# SR-400 CYCLONE TO SR-400 CYCLONE II UPGRADE

WRITTEN BY WDØGOF

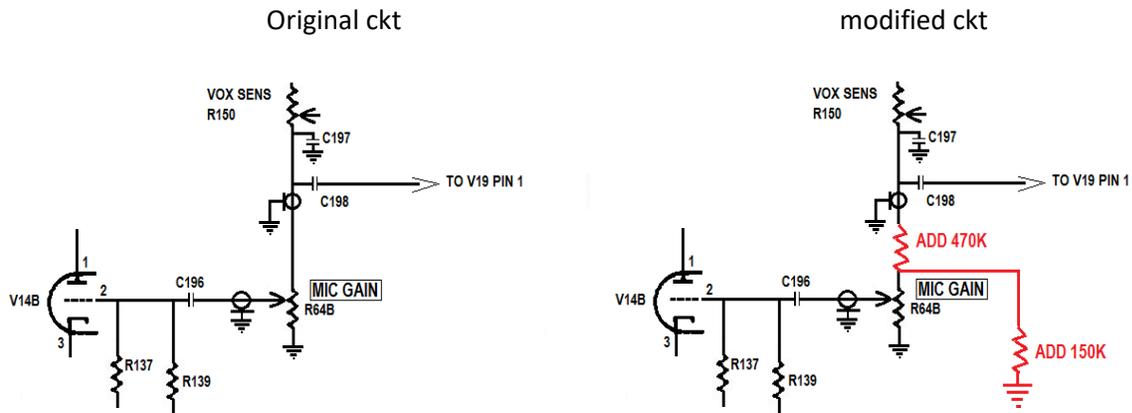
- J. Add a 180pf capacitor from pin 7 of V2B to gnd.
- K. Add a 1N456 diode from the cathode of CR15 to ground, with the anode to the cathode of CR15 and the cathode to ground. This part may be salvaged from stripped parts see page 5.
- L. Disconnect C8 (Pin 7 of V7A) from pin 3 of T3 and connect it to ground.
- M. Add a .005 capacitor from pin 3 of T3 to ground.
- O. Add 100k resistor from V1 pin 6 to gnd
- P. Change C48 (22pf) to 33pf. (pin 2 V4)
- Q. Change C16 (22pf) to 47pf. (pin 1 V4)

# FL1 & NOTCH FILTER MODIFICATION

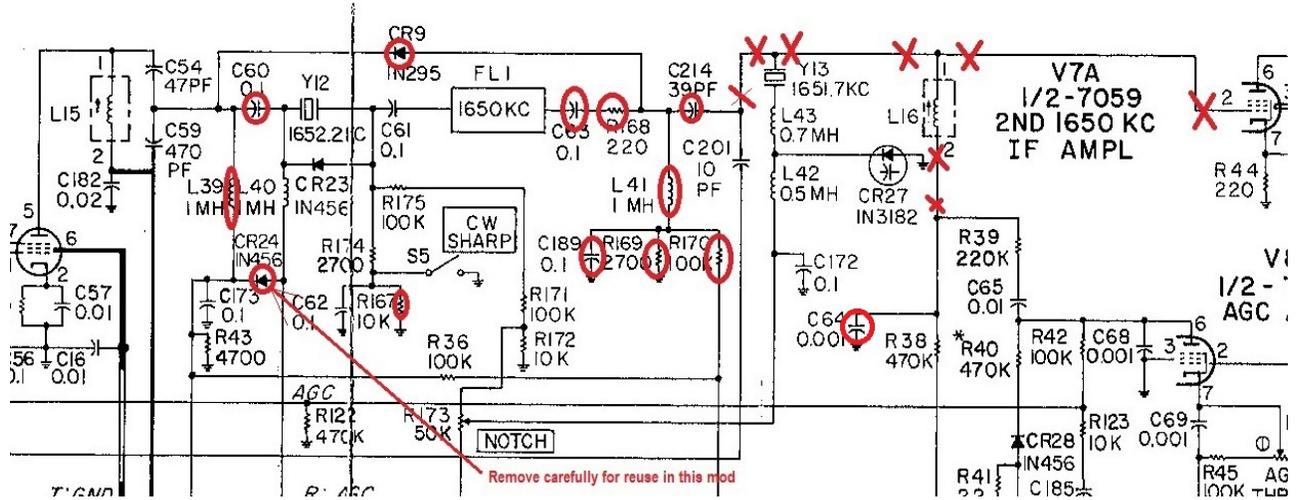
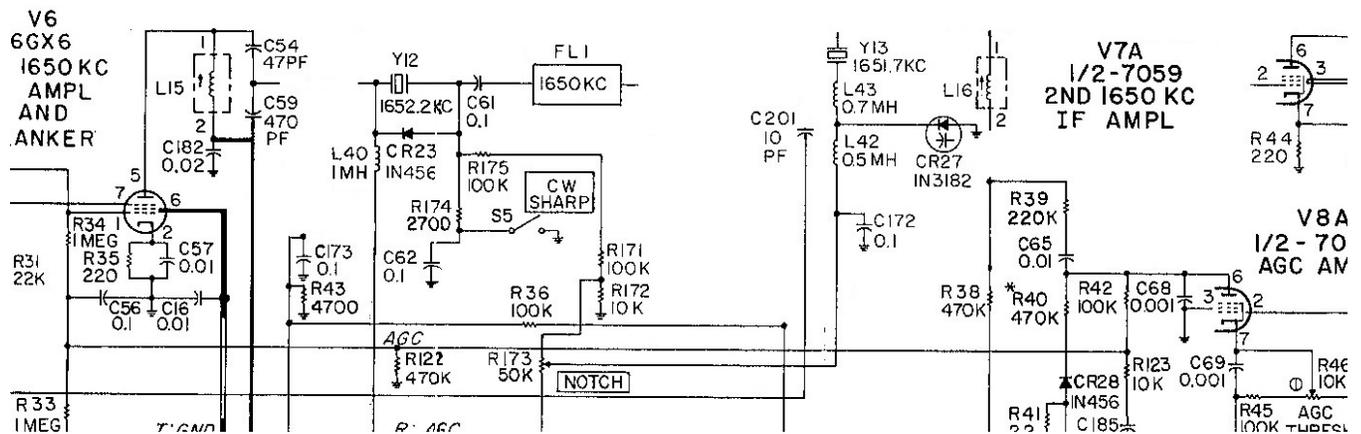
The parts circled in red will be removed and discarded. Wires marked with red X will be removed.

When disconnecting wires and components from L16 note which pins are 1 and 2. The other pins (3 & 4) of L16 are not internally connected and can be used as tie points for adding components. Very handy....

Your chassis should now look like this.

# FL1 & NOTCH FILTER MODIFICATION cont.

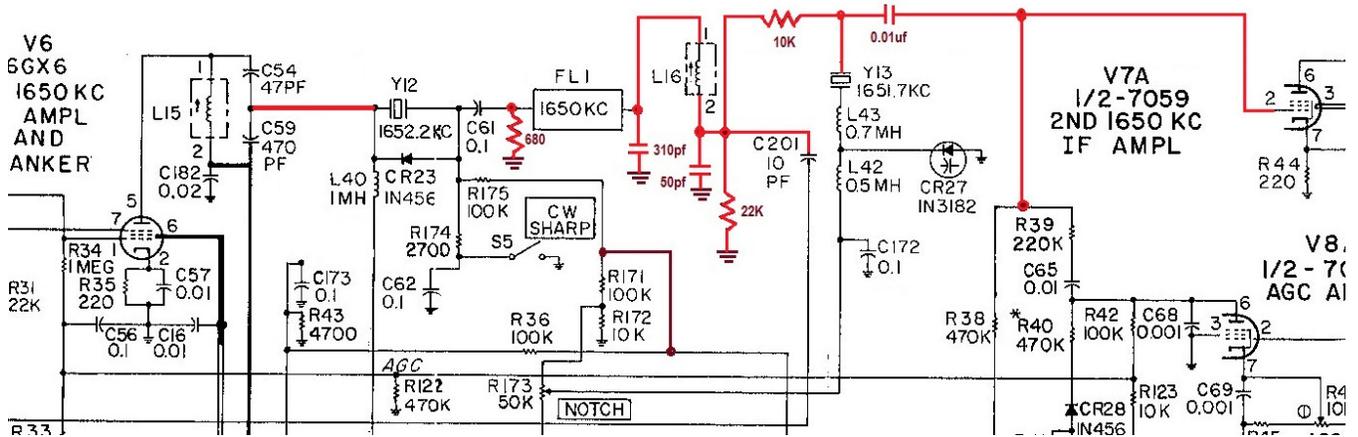
Add and connect components as marked in **RED**.

**Note:** There is a conflict with the F level schematic and prior production runs. The schematic shows the 10K resistor R169 connected to pin 1 of L16. Some production runs it is connected to pin 2 as indicated above. The jury is still out on this one. There was an internal change in FL1. They did not make any change to the part # of the filters after the change. The original filter works best with the 10K resistor connected to pin 1. Later production run filters work better with the 10K connected to pin 2. All I can offer at this time is try the connection to pin 2 first. If the receiver is weak try pin 1.

## C27 INSTALLATION AND LOCATION

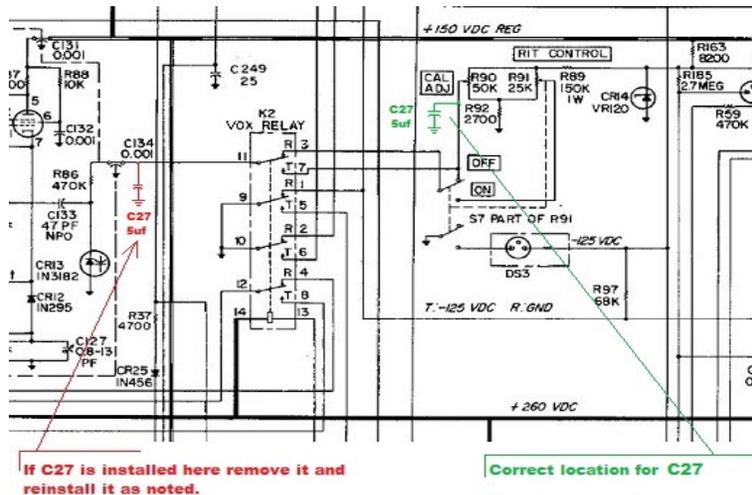
The existence of and placement of C27 although not a part of the upgrade should be noted. There is a chirp and or FM problem in all the SR series radios. C27 eliminates the problem unfortunately it was installed in the wrong place. NOTE the drawing above.
